Our Case Number: ABP-321144-24

Re: Proposed development of a public realm scheme in Clifden, County Galway, Townland of Clifden, County Galwy

Re: Case No ABP-321144-24 Response to Further Information

Reproduced below is table 1-5 from the report, outlining the parking spaces retained

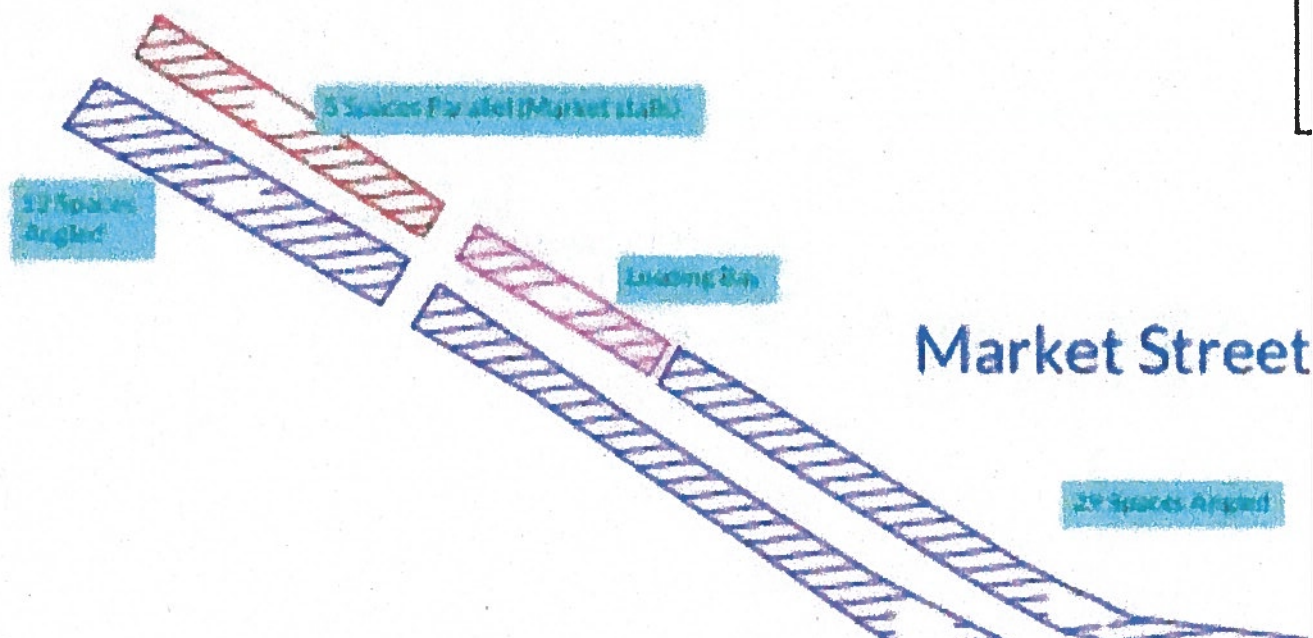
This does not correctly answer the question asked in the Further Information Request. The number of parking spaces proposed to be removed from the Town Centre is 100 or 103, depending upon which documents in the Application/Further Information submission are used as a basis.

The 213 spaces referred to in section 1.3.3 of the report is the sum of spaces on Main Street, Market Street and Bridge Street less the parking spaces used for outdoor dining in 2021. It does not include parking spaces on Seaview or Railway View (Market Hill). It does not include the five parallel parking spaces which double as market stall spaces on market days. It does not include the 12 parking spaces reserved for outdoor dining at the time of the parking survey.

By contrast, the retained 150 parking spaces are all the parking spaces to be included on Main Street, Market Street and Bridge Street PLUS Seaview (the portion in scope) and Railway View (Market Hill).

The two figures, 150 and 213, are counts of parking spaces in two different areas. The retained parking spaces count is from a bigger area than the existing spaces count area which is very misleading and leads to an incorrect figure of a loss 63 parking spaces.

It is inappropriate not to consider the parking spaces dedicated to outdoor dining at the time of the Car Parking Survey. The absence of Market Hill and Seaview is evident in table 1-1. It is inappropriate not to consider the existing parking spaces on Railway View (Market Hill) and the portion of Sea View that is within the scope of the proposal which seeks to remove parking spaces from these streets. I would suggest that these areas were missed in the original analysis simply because the survey did not monitor them for the occupancy analysis.

In response to the Further Information Request, the Applicant has reiterated that there are 150 retained parking spaces as per table 1-5 of the report and my analysis of the existing spaces is 253 as above. Therefore, the number of parking spaces lost is 103 spaces or 41% of the existing number of spaces.
